STARTER SWITCH CHANGE

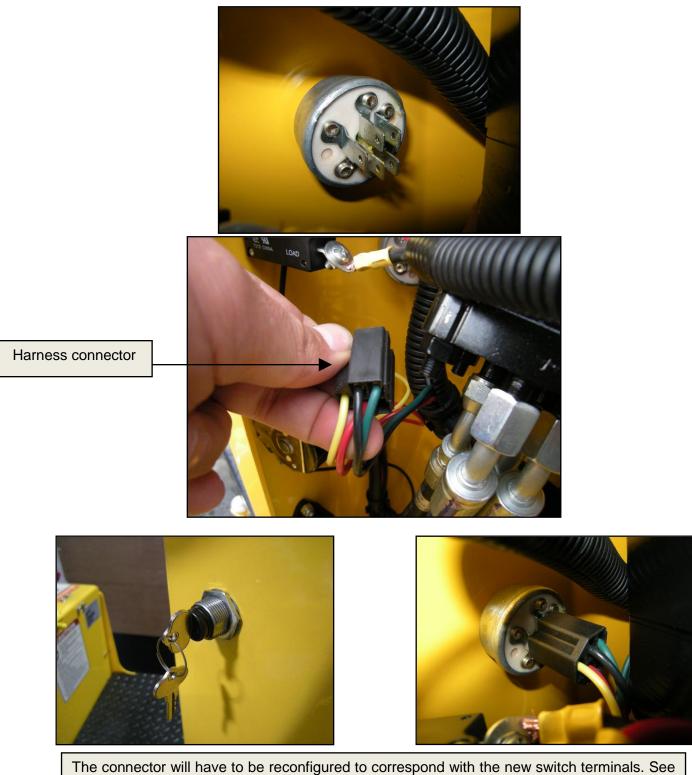
The starter switch has been changed from a 5 terminal switch to a 6 terminal switch. The part number remains the same. The new switch has an extra terminal which is not used. It will require the technician to reconfigure the harness connector to match the new terminal positions. The extra terminal should be removed.

page one, terminal configuration is different between old switch and new switch.
